# **ADDENDUM NUMBER: ONE [1]**

PROJECT: Provalus Whiteville

DATE: November 20, 2024

Drawings and Project Manual dated <u>October 30, 2024</u>, for this project are hereby modified, corrected, or supplemented as follows:

FIRST FLOOR PLAN

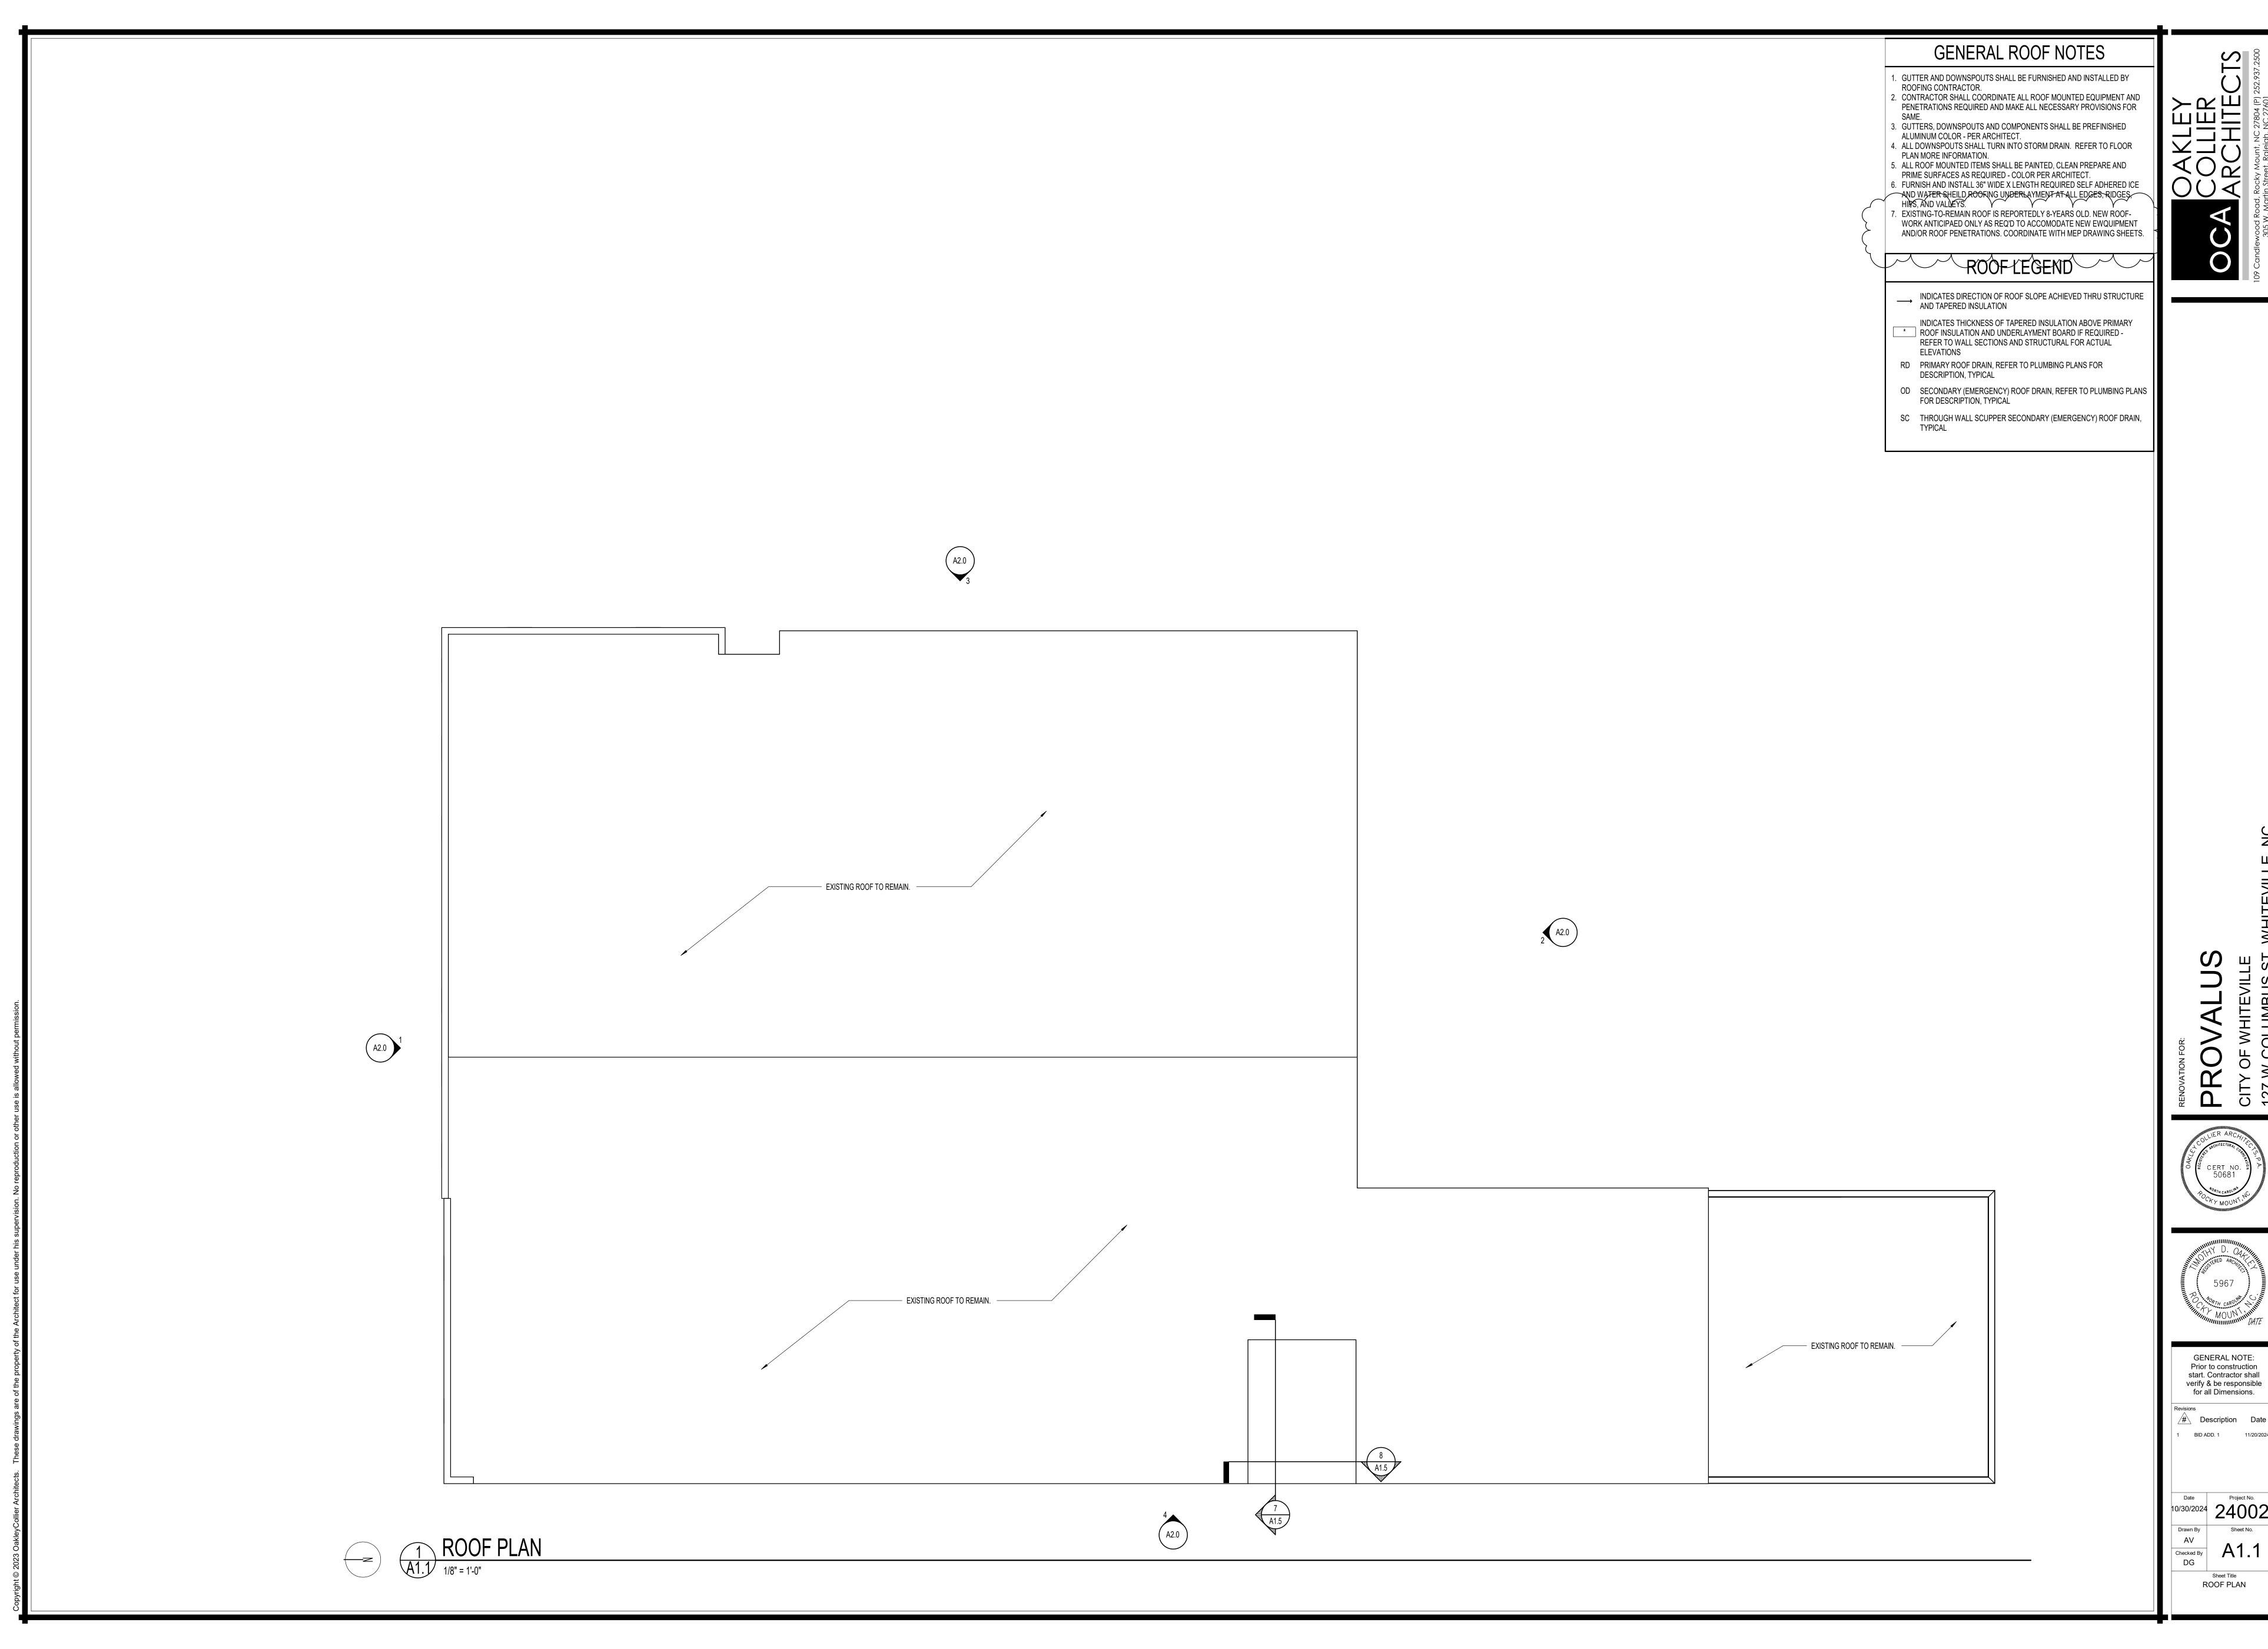
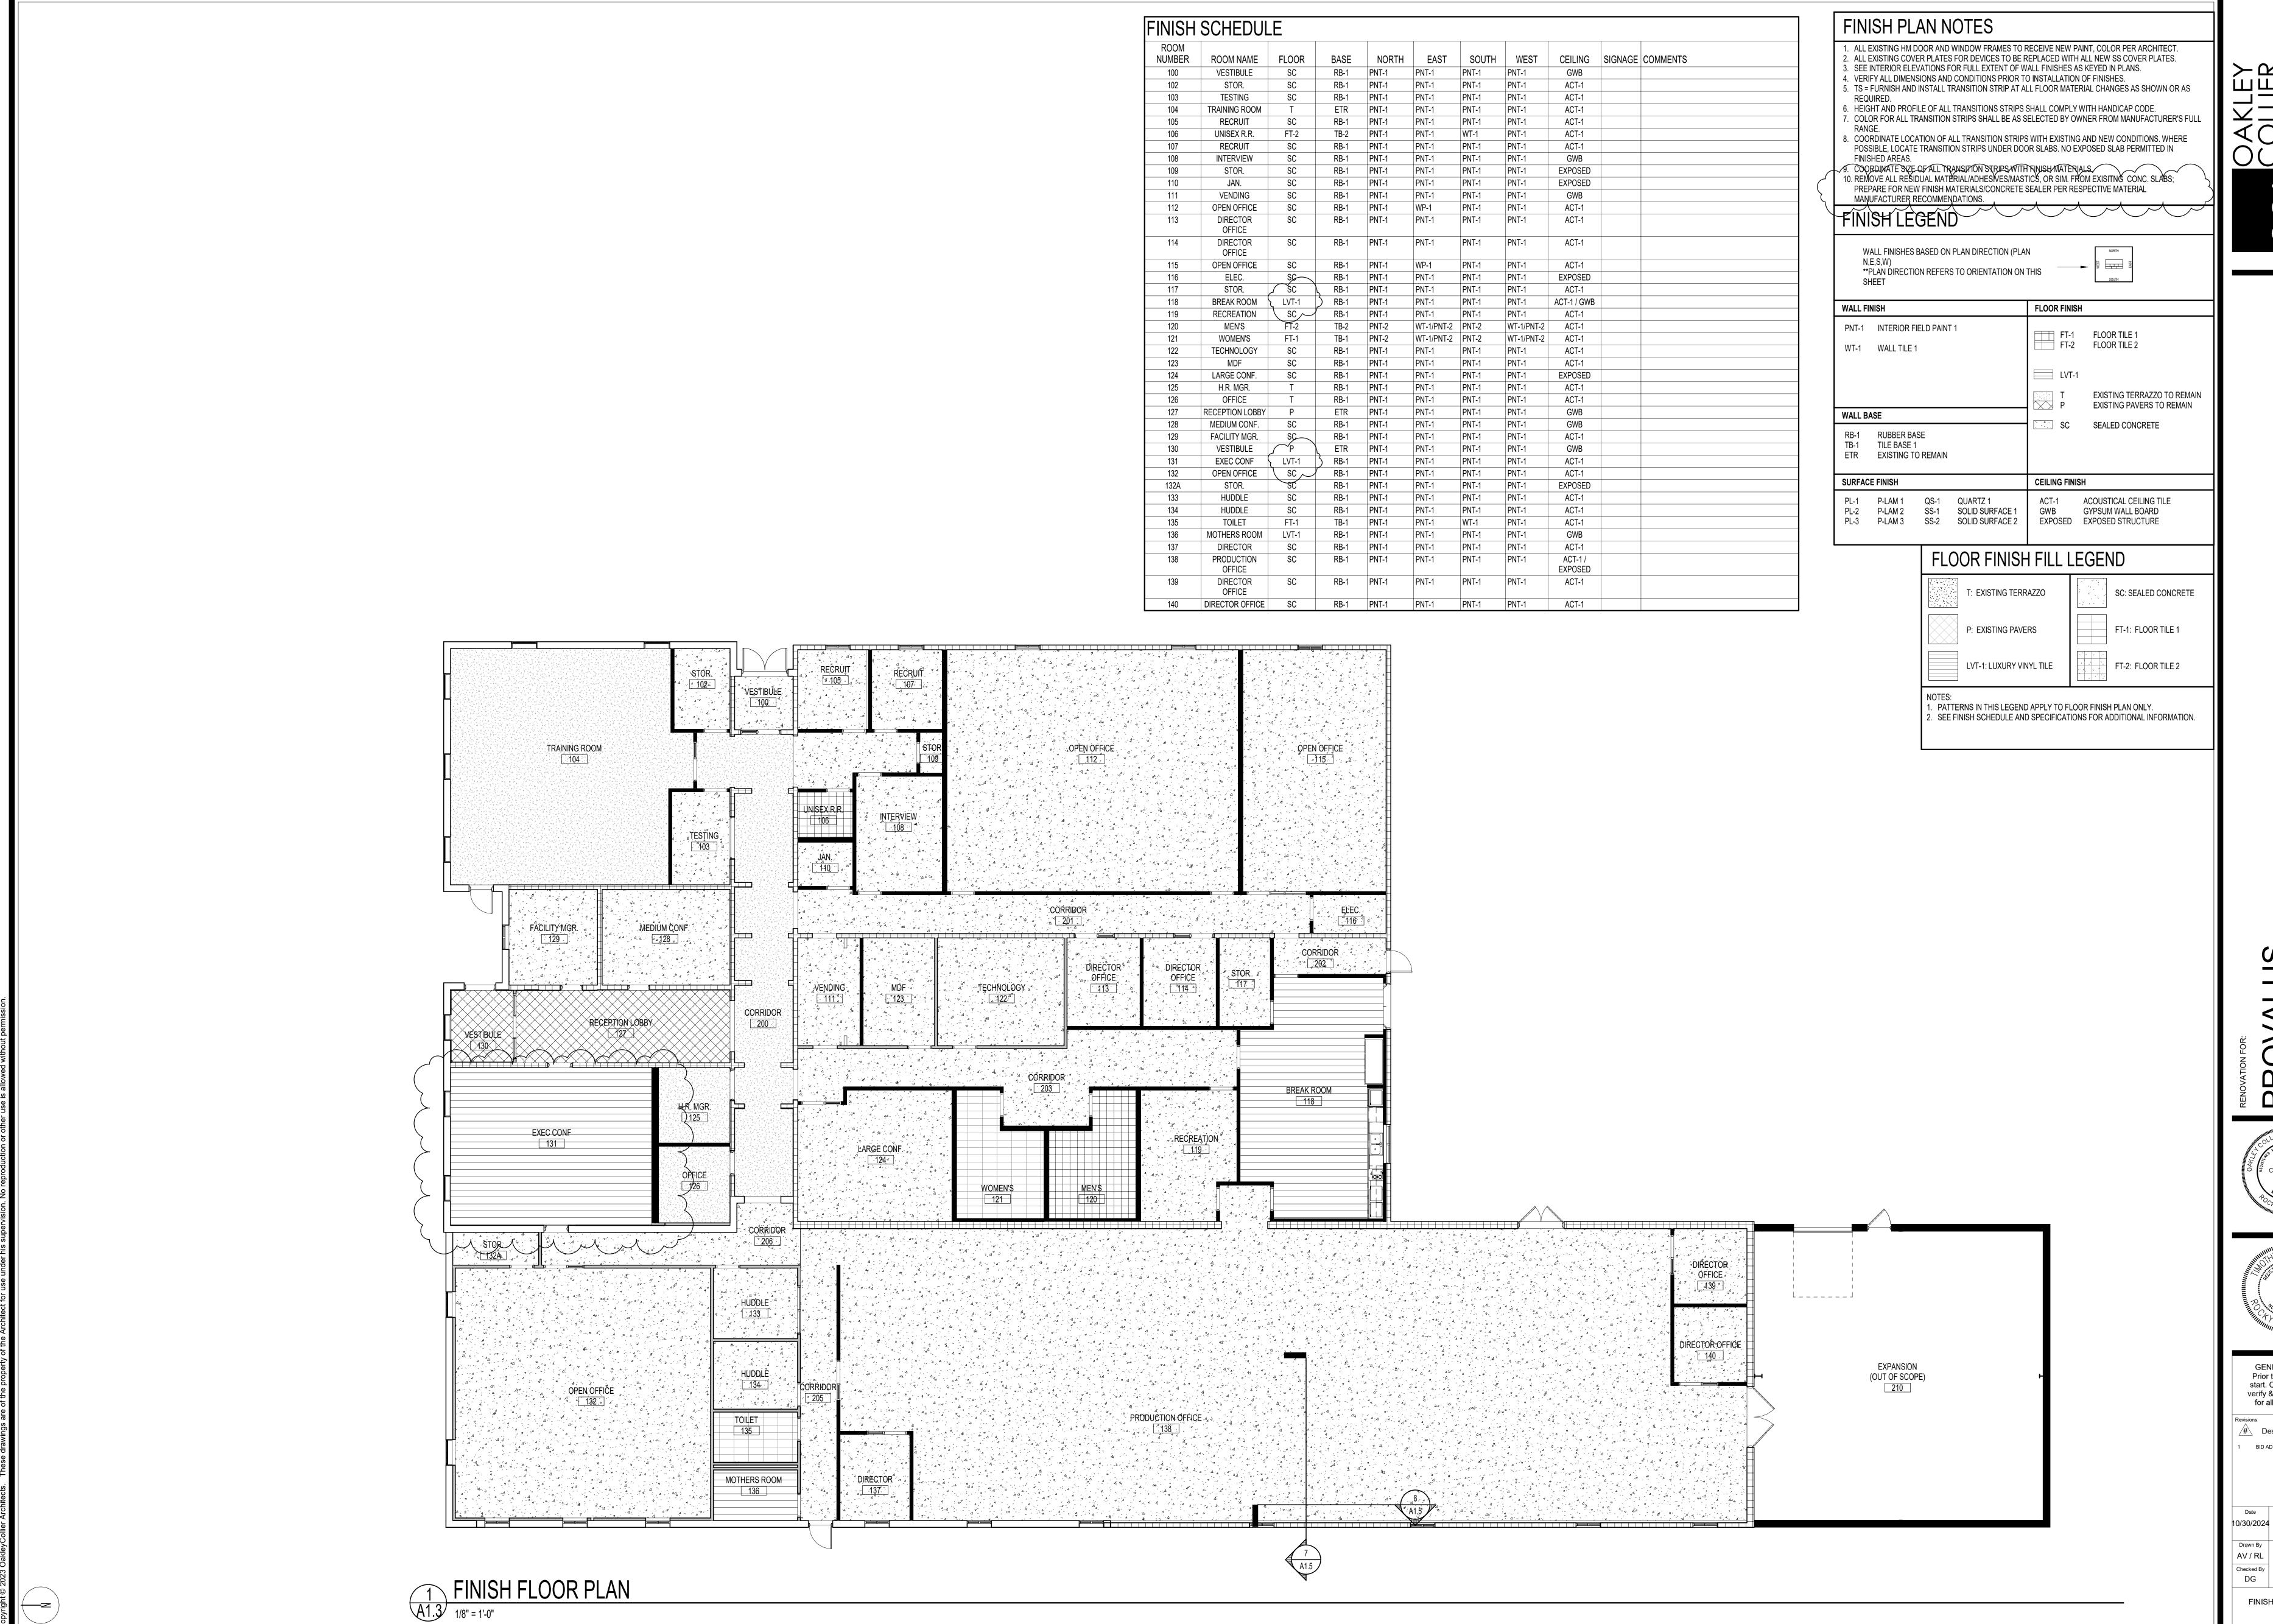
Item <u>5</u> Revision Sheet A1.0 – First Floor Plan

Omitted lockers in Mother's Room
